CAA Operational Assessment

Title of airspace change proposal	CAELUS Trial D – Lothian region
Change sponsor	AGS Airports Ltd
Project reference	ACP-2022-104
Account Manager	██████████
Case study commencement date	29 February 2024
Case study report as at	17 June 2024
<p><i>Instructions</i></p> <p>In providing a response for each question, please ensure that the ‘status’ column is completed using the following options:</p> <ul style="list-style-type: none"> • YES • NO • PARTIALLY • N/A <p>To aid the SARG Lead it may be useful that each question is also highlighted accordingly to illustrate what is:</p> <p>resolved YES not resolved PARTIALLY not compliant NO</p>

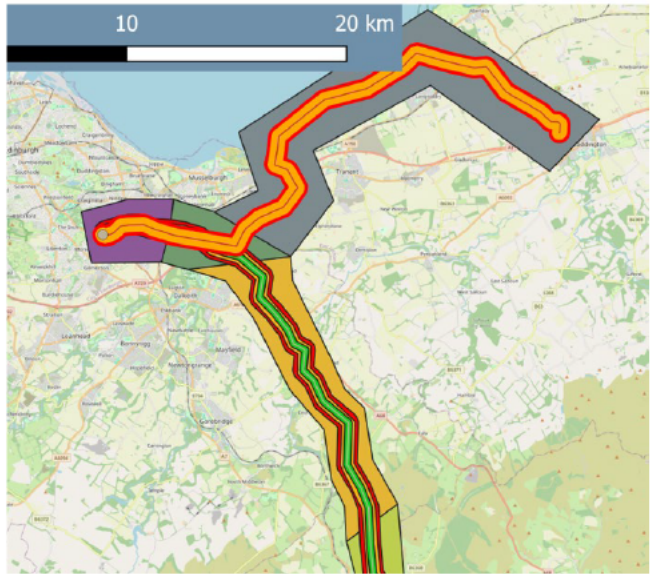
Taking the bullet points in order:

- It does not make sense that just because an alternative route would be entirely over land, the ground risk therefore cannot be ALARP. **The sponsor has not provided any additional evidence to support this position.**

- A route developed by the RPAS team as an example route to the south (which could potentially be further refined) would add less than a minute of flying time to the currently proposed route. **The sponsor has not provided any evidence of the route or routes that they examined to substantiate the statement that an alternative route would be longer than the proposed route.**

- In the RPAS operator's submission to the RPAS Team, they indicate that with the currently proposed route, the aircraft would use 60% of the aircraft's max endurance which would **indicate that battery swap is required for this route anyway** (although the figures do not seem to match when compared to the EDI-Borders route). The sponsor has not provided any evidence of the route or routes that they examined to substantiate the statement that an alternative route would be longer than the proposed route.

- The example route produced by the RPAS team did not use any turns that were tighter than turns already used in the proposed route. **As the sponsor has not provided any evidence of the route or routes that they examined to substantiate the statement that**

<p>an alternative route would require tighter turns than the proposed route, the claim cannot be assessed.</p> <p>Given the above, the sponsor has not provided sufficient justification that the proposed route is the most suitable, given the stakeholder feedback received.</p>	
1.4	Is the justification for the selection of the proposed option sound and acceptable?	NO
	<p>Given that the sponsor has not considered the route proposed by the BMAA, it is not clear that the selected option is the most suitable.</p> <p>See 1.3</p>

10/06/2024 submission of additional info

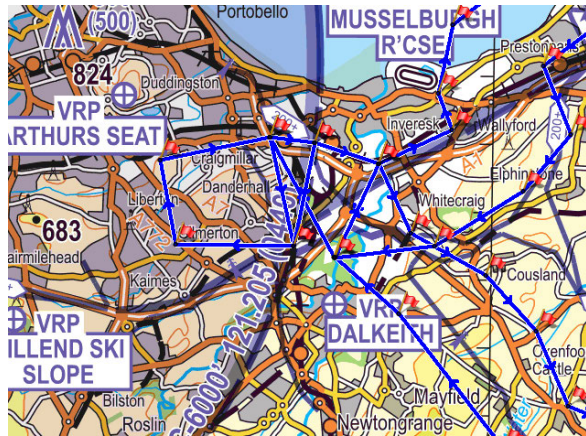
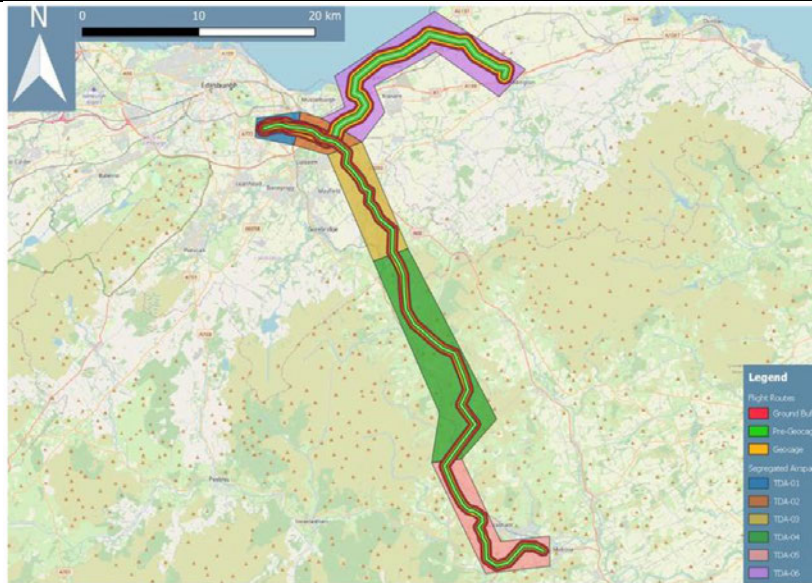
2.	Airspace description and operational arrangements	Status
2.1	Is the type of proposed airspace design clearly stated and understood?	YES
	<p>The coordinates provided for the airspace design do not match that provided in the image of the proposed TDA/TSA complex in the proposal or in the draft LoA with between ANSL and Skyports.</p> <div style="display: flex; justify-content: space-around;">   </div>

In a meeting between the CAA and the sponsor on 18/04/24 it was pointed out that the boundary between TDA 3 and TDA 4 only allowed approx. 300ft from ground level to the upper limit of the TDA at 1,400ft AMSL. **Following the resubmission of the proposal, the sponsor provided a mixture of different diagrams of the proposed TDA/TSA complex.** In the final submission the sponsor confirmed that the diagram provided in the ACP and the coordinates were the final proposed design.

The diagram above is the pictorial description of the proposed TDA/TSA complex, but there is still a discrepancy between the proposed design and the design described by the coordinates provided in the draft AIC.

The coordinates describe a boundary between TDA 3 and TDA 4 that still only leaves 300ft of vertical space whereas the diagram suggests that the design is intended to have the boundary further north.

Following the resubmission of the ACP document (v9), the coordinates now match the proposed airspace diagram and can be used to produce the draft AIC if approved. Recommend raising the upper limit of TDA 4 to the nearest 100ft (1700ft from 1650ft) to ensure that the structure is as clear as possible to other airspace users.
